Dear Kia Sportage Owner:

This notice is sent to you in accordance with the requirements of the National Traffic and Motor Vehicle Safety Act. Kia Motors America, Inc. has determined that a defect relating to motor vehicle safety exists in relation to 2000 model year Sportage models. This constitutes a error in your Owners Manual that incorrectly describes jump starting procedure. If the incorrect jump starting procedure is used, the battery could rupture, causing potential serious injury.

#### Connecting Jumper Cables

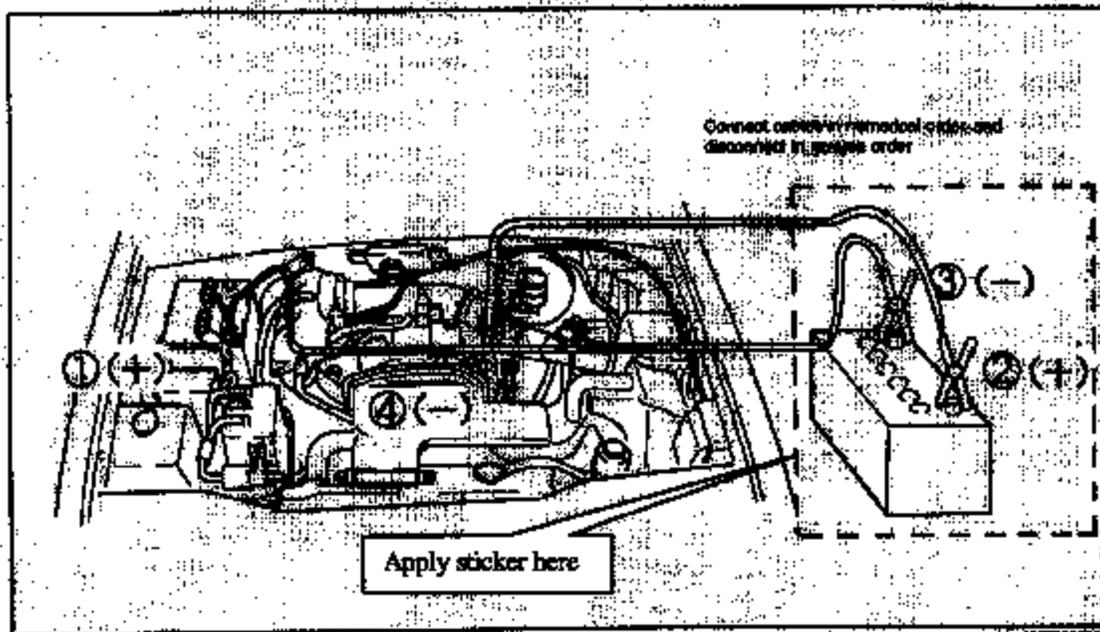
1. Open Owners Manual to page 6-5, which is the jump starting diagram shown below.

To correct this error, we have enclosed a sticker for you to apply to the page with the error in your Owners Manual. Please apply this sticker using the instructions below:

2. Peel off the yellow paper backing on the sticker, and carefully apply it over the location indicated on the diagram.

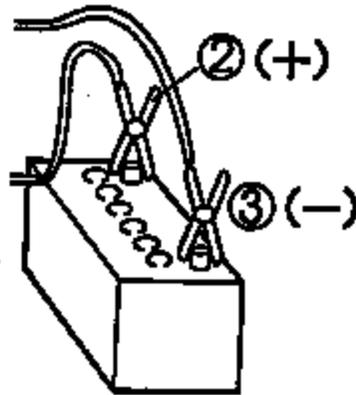
Take off the illustration shown above and stick it on page 6-5 in the owner's manual.
